# Service Bulletin

Conversion from FAR 36 noise compliance (2700 RPM, full throttle take off power) to ICAO Annex 16 noise compliance (2500 RPM, full throttle take off power).

SB-GA8-2005-16	Issue: 1	Date of Issue: 16 August 2005	Page 5 of 5
----------------	----------	-------------------------------	-------------

Figure 1 – Gate installation

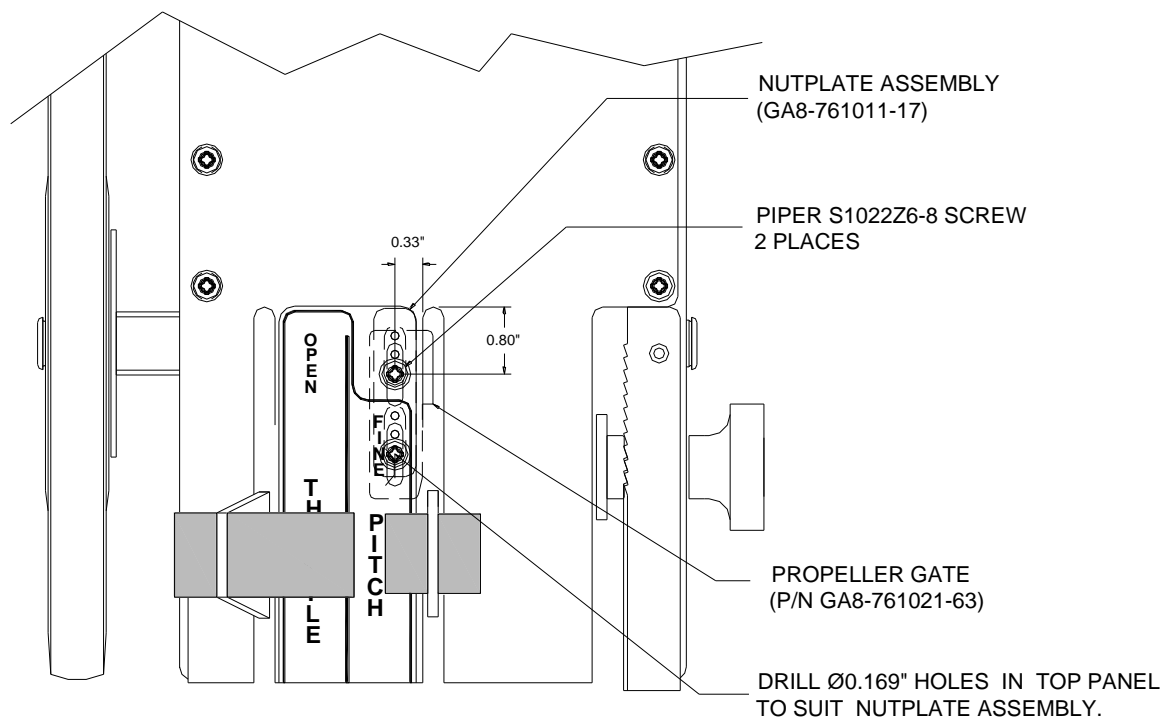
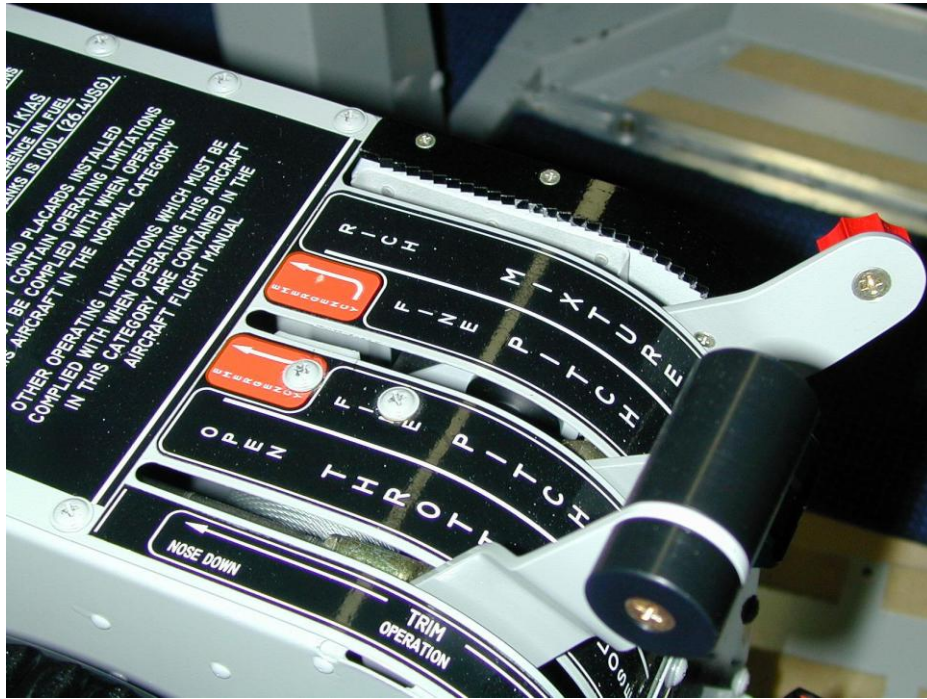
1. Remove existing throttle quadrant placards.
2. Install new throttle quadrant placards (P/N GA8-112011-163 and GA8-112011-165).
3. Install propeller gate (P/N GA8-761021-63) and nutplate assembly (P/N GA8-761011-17). Refer to Figure 1.
4. To set take-off rpm:
  - (i) loosen propeller gate attaching screws.
  - (ii) start engine and warm up.
  - (iii) cycle propeller control several times to ensure that warm oil has circulated through the propeller.
  - (iv) advance the throttle until the propeller is governing.
  - (v) retard propeller control until 2500 rpm is set on the tachometer.
  - (vi) set propeller gate abutting the propeller control and tighten attach screws
  - (vii) check that the propeller control may be advanced past the gate to obtain 2700 rpm.
